**RE: Water Licence 2AM-MRY1325 Baffinland Response to September 2021 Inspection**

The following submission from Baffinland Iron Mines Corporation (Baffinland) is a follow up in response to the Water Licence Inspection conducted on September 16-17, 2021, at Baffinland's Mary River Project (the Project) by the Crown-Indigenous Relations Northern Affairs Canada (CIRNAC) Water Resource Officer, and subsequent communications between Baffinland and the CIRNAC Water Resource Officer.

Attachment 4 – Knight Piesold's Memorandum - Mary River Project - Remediation of Seepage from the KM106 Stockpile

**Figure 2 As-built Survey at MS-106OS-01 Showing Flat Topography**

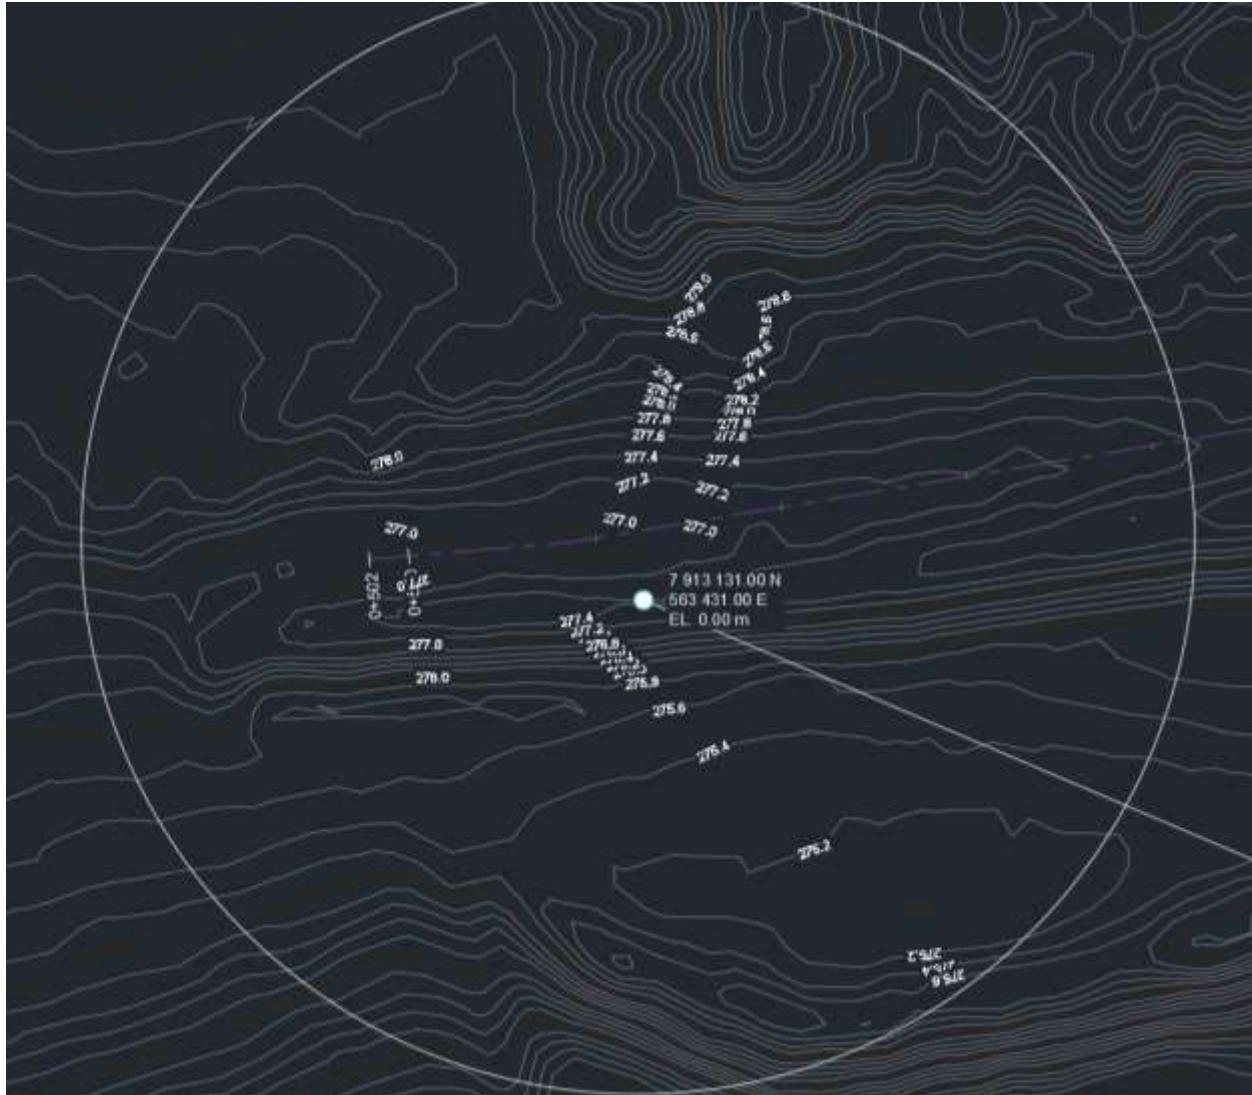
KP's review of the August 2021 drone survey indicates that the diversion ditch adjacent the seepage location MS-106OS-01 is flat, with multiple 277.0 m elevation measurements along the ditch alignment (Figure 2).

The drone survey suggests that settlement has occurred such that positive drainage is no longer present in this area.

KP recommends that additional grading be completed as a first course of action once the ground has sufficiently thawed. Ongoing surveillance and grading will be required to maintain positive surface drainage towards the sedimentation pond in the area upstream of the collection/diversion berm.

- Regrade the existing collection/diversion berm to re-establish positive drainage towards the Sedimentation Pond
- Continue to monitor and if required, recover seepage through the snow-free period in 2022 using the infrastructure currently in place until seepage is substantially reduced or an engineered solution is implemented
